Task 30
Sump 1727
Interim Response Action
Alternatives Assessment
Final Report
Version 3.2

Task 30
Sump 1727
Interim Response Action
Alternatives Assessment
Final Report
Version 3.2

APPENDIX A -- COMMENTS AND RESPONSES TO THE TASK 30 SUMP 1727
INTERIM RESPONSE ACTION ALTERNATIVES ASSESSMENT
DRAFT FINAL REPORT, MAY 1988

APPENDIX A
COMMENTS AND RESPONSES TO THE
TASK 30 SUMP 1727 INTERIM RESPONSE ACTION
ALTERNATIVES ASSESSMENT DRAFT FINAL REPORT
MAY 1988

Figure 3.3-1
POTENTIAL SOURCE AREAS
SOURCE: ESE, 1987

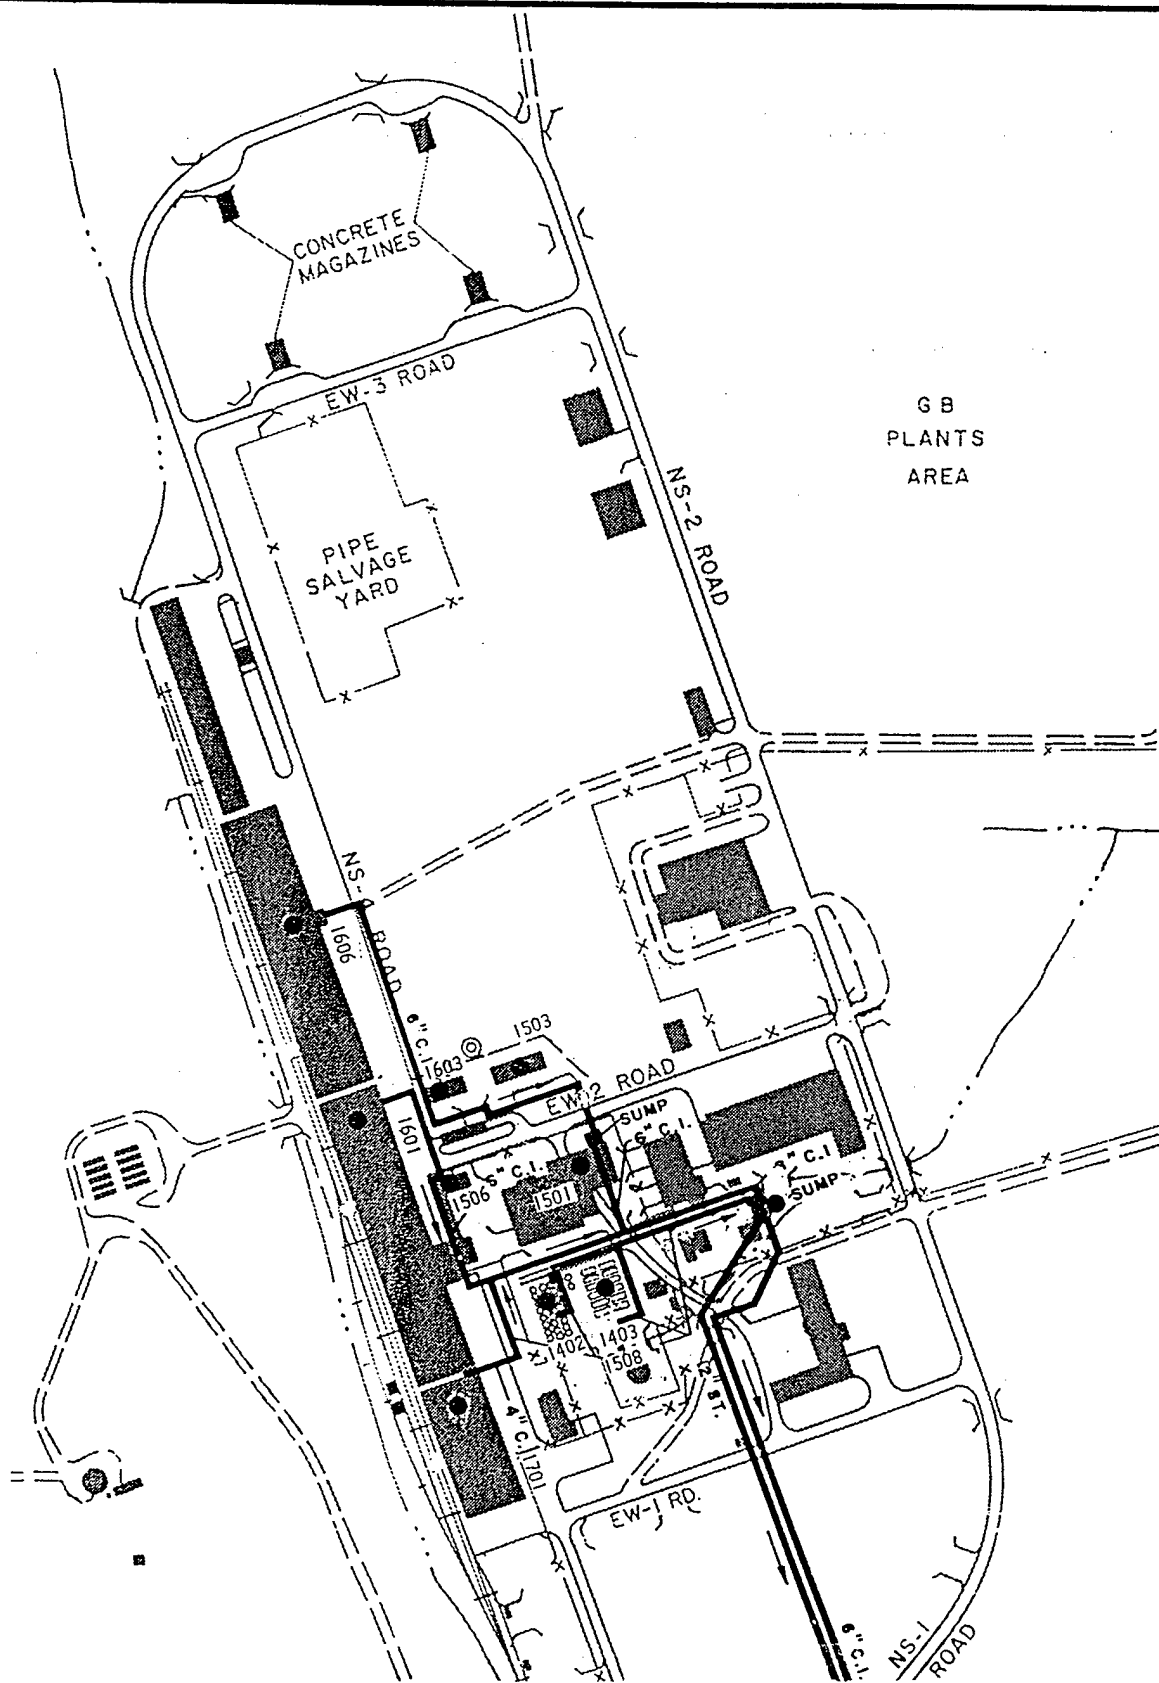
5. Page 3-11, Figure 3.3-1.
